Docket No. 50-423
B12024

Millstone Nuclear Power Station, Unit No. 3
Response to Information Requested
Regarding Station Blackout
Technical Review

March, 1986

FIGURE 2.2-4. Time line for NUREG-1152 Case (1) (short term scenario)

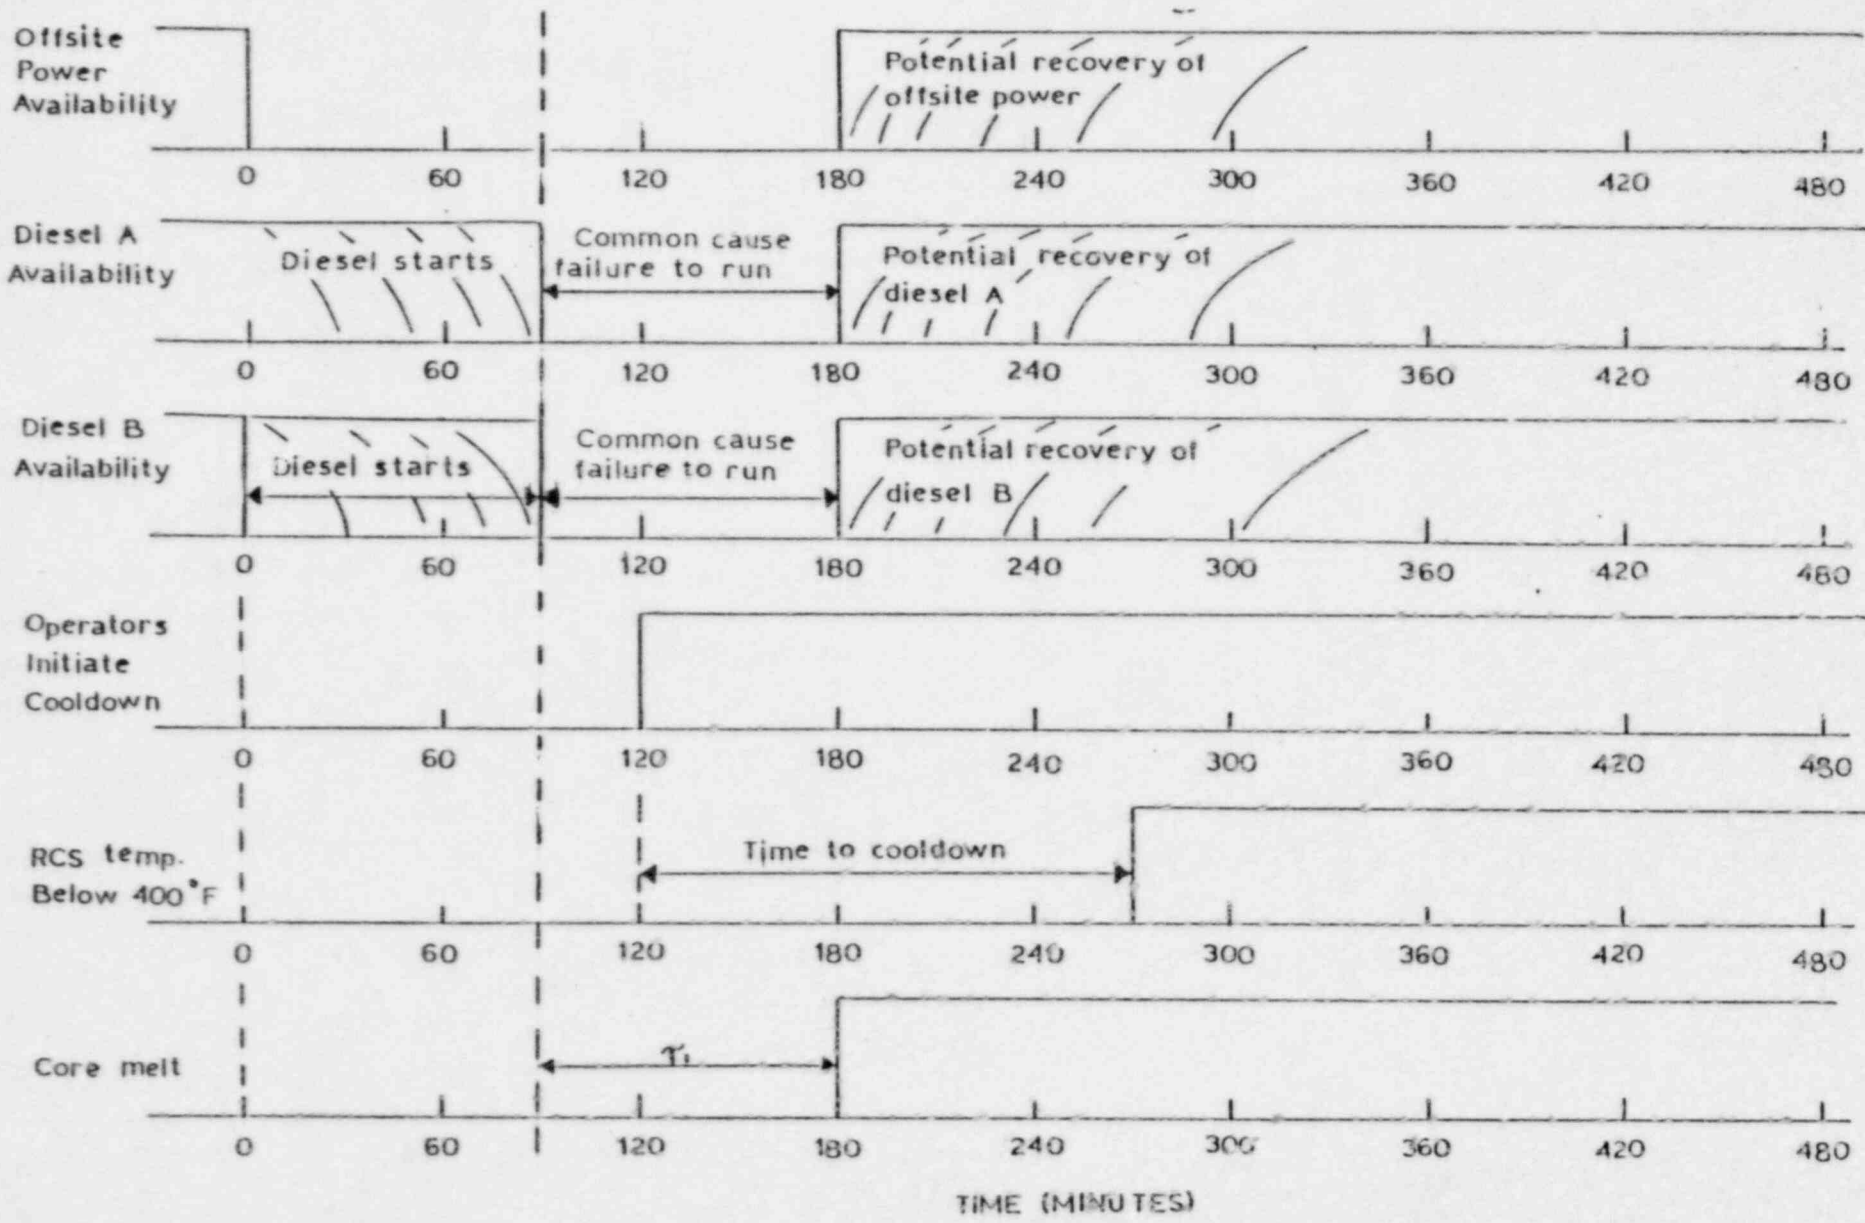
The split integration limits on the convolution integrals are based on an incorrect assumption related to the ability to cool down below 400°F under Station AC Blackout conditions.

The "grace time" should be treated as a random variable rather than a conservatively estimated fixed parameter.

The term: $\exp(-2\lambda_1 w)$ appears to be incorrect. The corrected equation should read as follows:

FIGURE 2.3-1

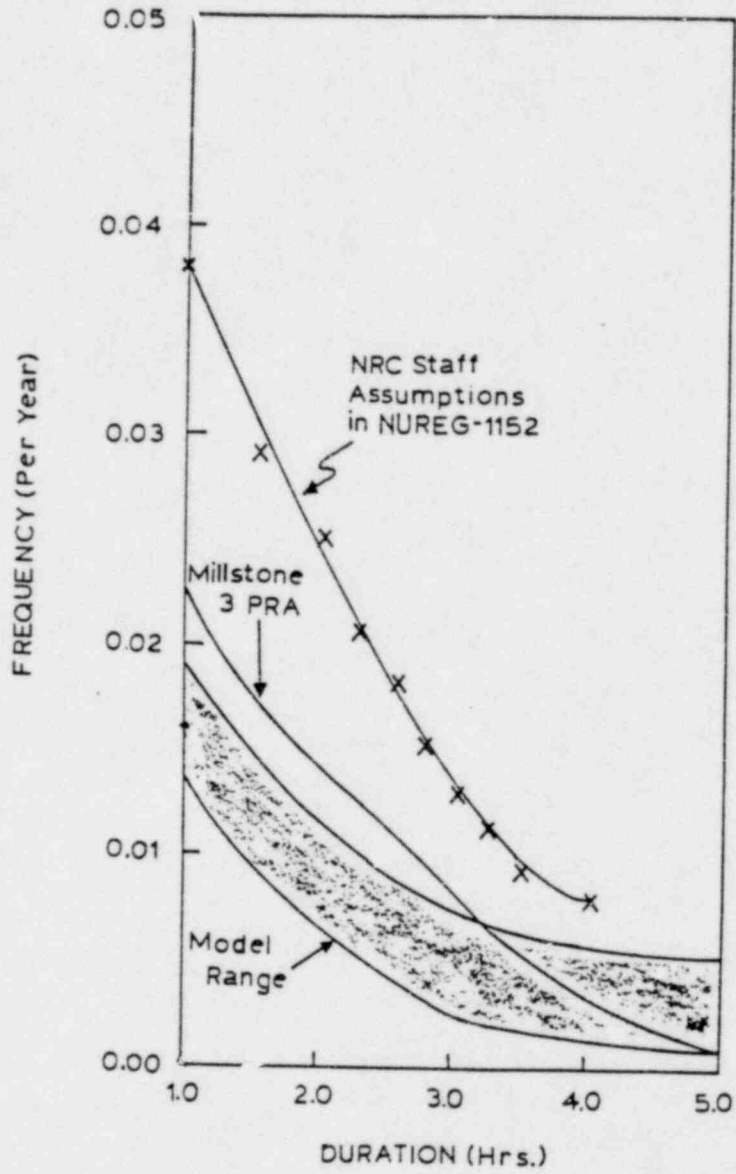
A detailed review of NUREG-1032 indicates that the actual values used by the NRC Staff in NUREG-1152 are not the midpoint values of the "Model Range" as stated. To the contrary, the values used are roughly factors of x2 greater than the midpoint values and are in fact greater than the upper confidence bound limits in the model. Figure 2.3-1 shows the values actually used in the NRC Staff's calculations overlaid on the "Model Range" which should have been used.

DIESEL FAILURE ON DEMAND PROBABILITY
 FIGURE 2.3-2. Comparison of diesel failure on demand probabilities

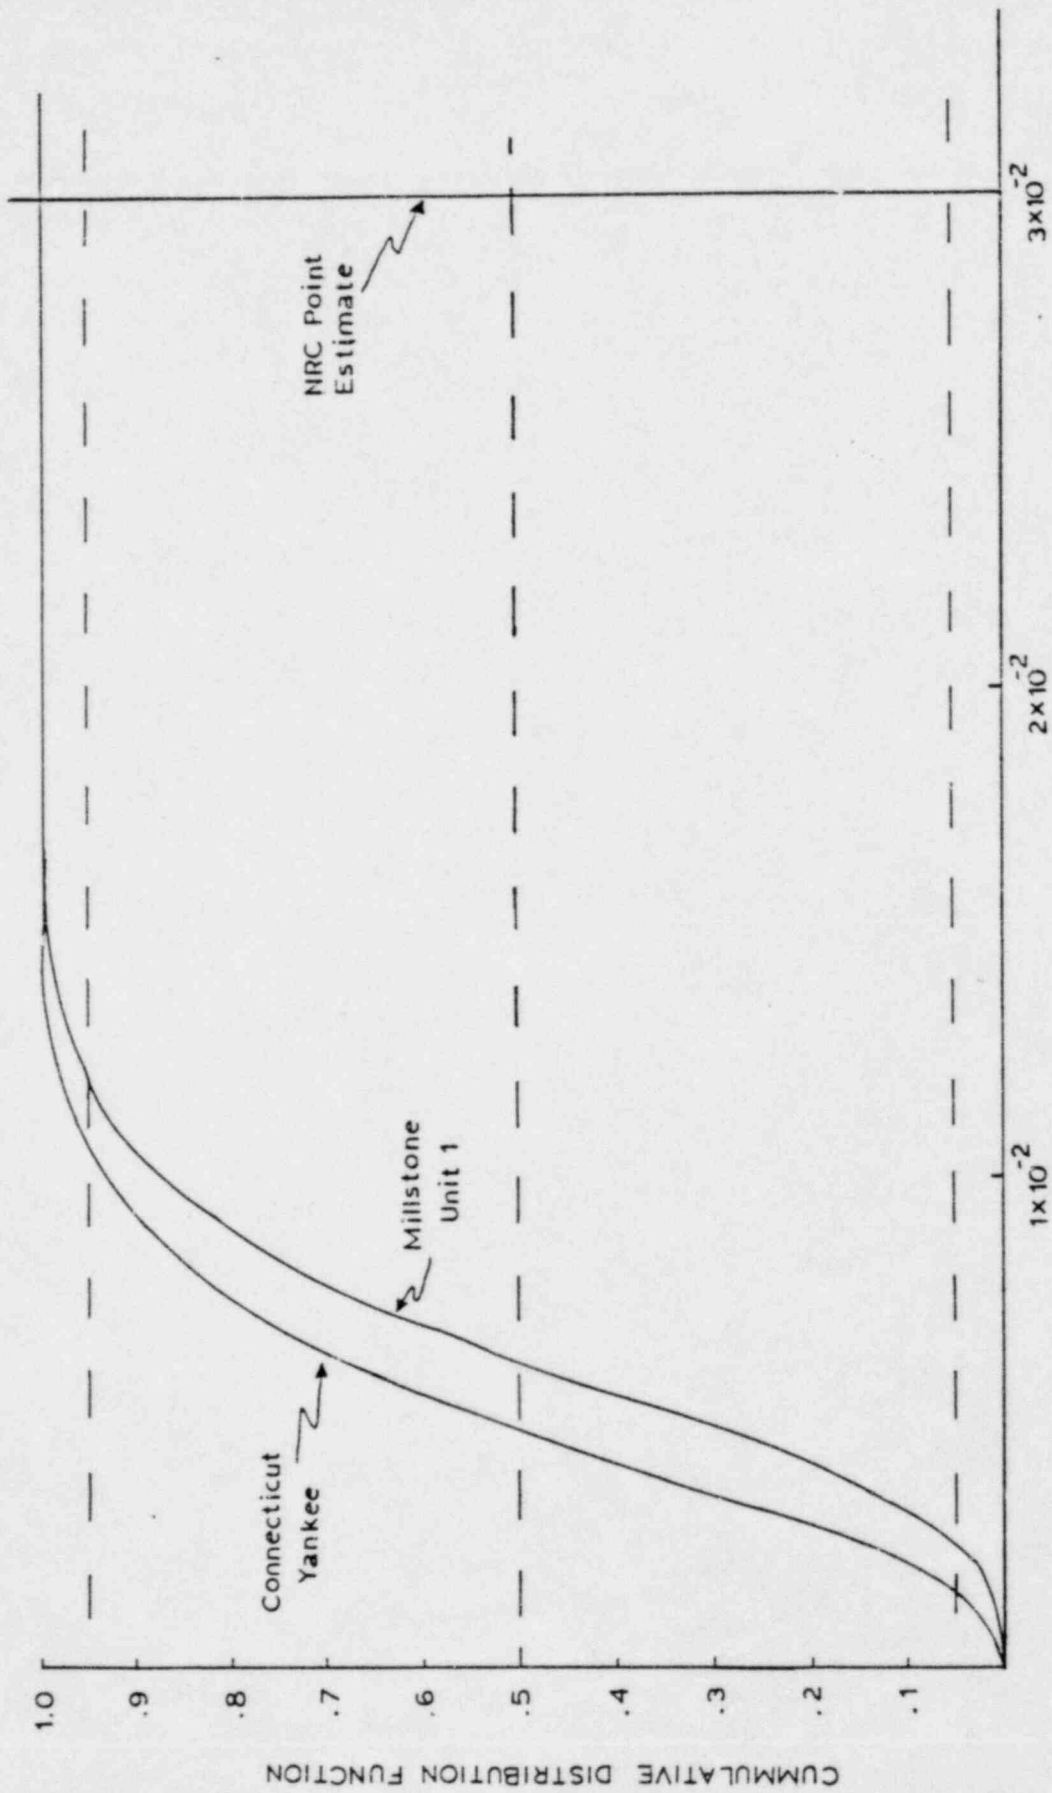
Based on Northeast Utilities operating experience, the value chosen by the NRC Staff is unrealistically conservative and is not a best estimate of diesel unavailability on demand. Detailed reliability analyses already performed for the diesels of two of our operating nuclear power plants are shown in Figure 2.3-2. (This data for the Millstone Unit 1 diesel has already been audited and reviewed by the NRC Staff and their consultants as a part of the ISAP.) Also shown on this figure is the NRC Staff's suggested value which is a point estimate without uncertainties. It is unlikely that the future diesel experience at Millstone Unit 3 will be significantly different from the Connecticut Yankee (Haddam Neck) and Millstone Unit 1 experience.

Our experience indicates that the q_f values used in NUREG-1152 are too large by a factor of x5 to x6.

Use of the more realistic best-estimate values in the equations results in a dramatic reduction in predicted core melt frequency due to Station AC Blackout of roughly 50%. In conjunction with the effects of using the correct frequency for loss of offsite power, this change has the result of reducing Station AC Blackout core melt frequency down to roughly $1.7 \times 10^{-5}/\text{yr}$.

FIGURE 2.3-3. Comparison of diesel failure rates given start

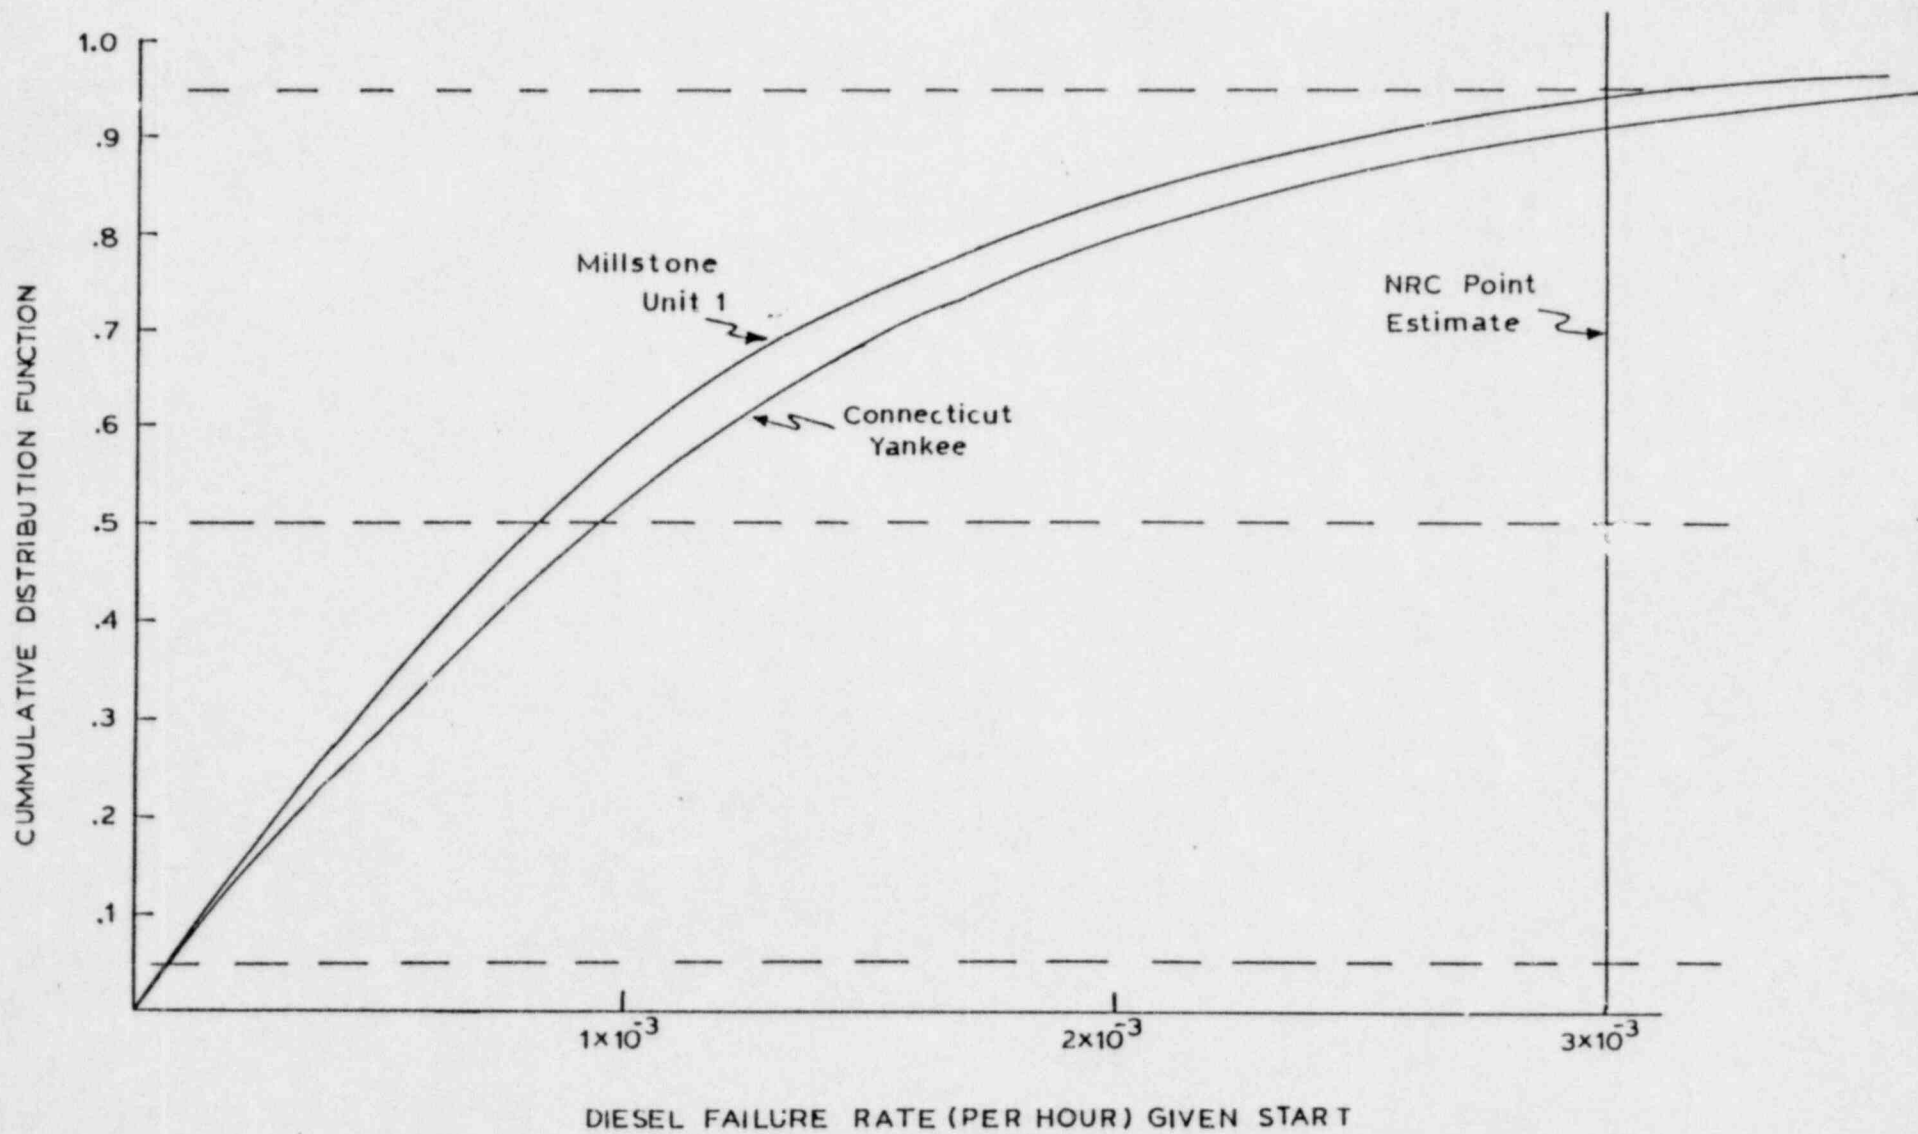
Based on Northeast Utilities operating experience, a value of $f = 3.0 \times 10^{-3}/\text{hr}$ (as a best-estimate for the Millstone Unit 3 diesel) is excessively conservative. Detailed reliability analyses already performed for the diesels of two of our operating nuclear power plants are shown in Figure 2.3-3. (The data for the Millstone Unit 1 diesel has already been audited by the NRC Staff and their consultants as a part of the ISAP.) Also shown overlaid on this figure is the NRC Staff's suggested value. It is highly unlikely that the future Millstone Unit 3 diesel experience will be significantly different from the Connecticut Yankee (Haddam Neck Plant) and Millstone Unit 1 experience.

FIGURE 3.1-2. Switchgear room heatup during station AC blackout

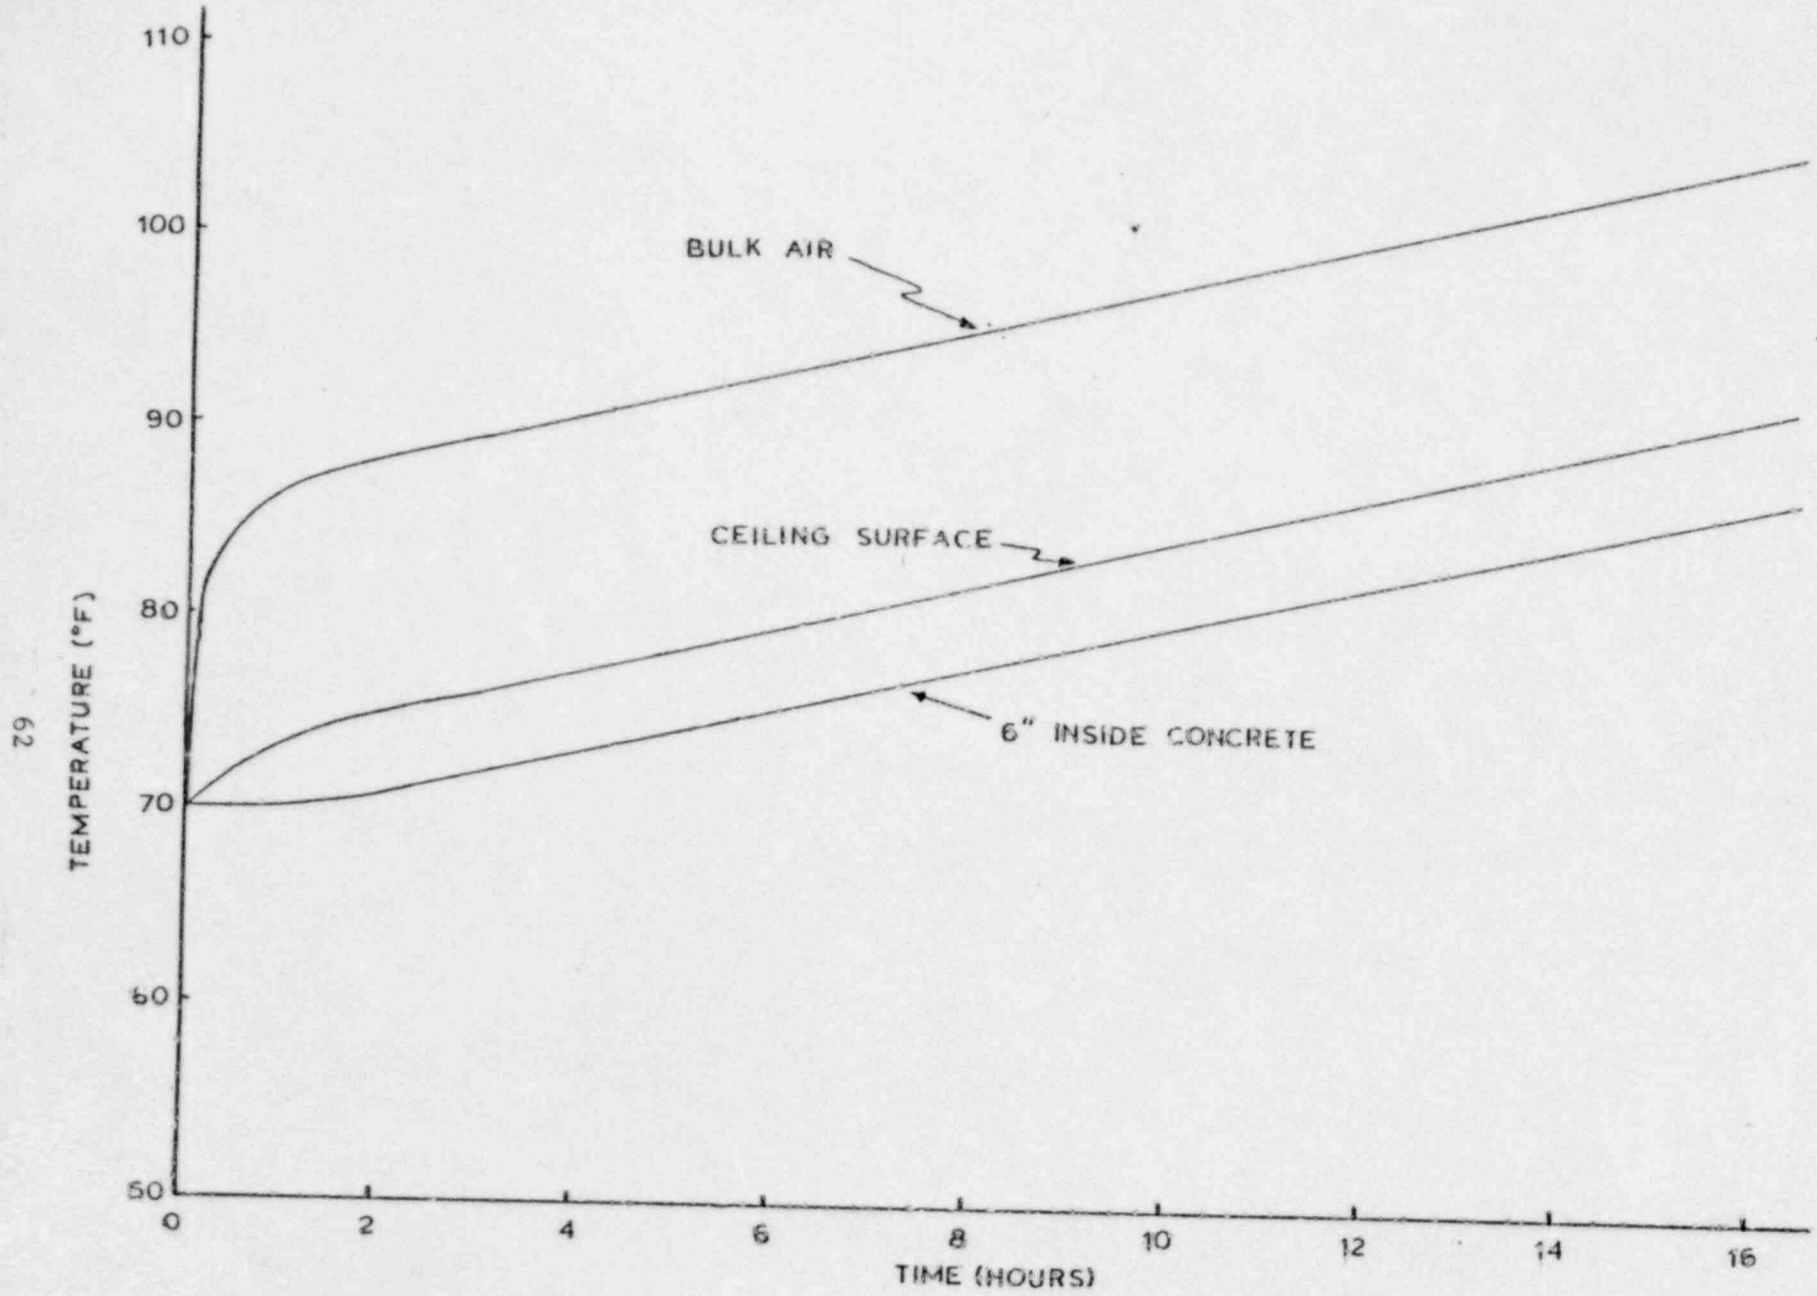
The results of the switchgear room heatup calculations are shown in Figure 3.1-2. As noted, it takes 12 hours just to heat the room up to

100°F. In view of this it is apparent that the NRC Staff's calculations indicating 2 hours to fail switchgear room components are based on unrealistically conservative assumptions. The length of time required to fail the inverters due to loss of room cooling is thus evaluated as being so long that it does not represent any real consideration in the Station AC Blackout issue (i.e., other issues would tend to dominate).
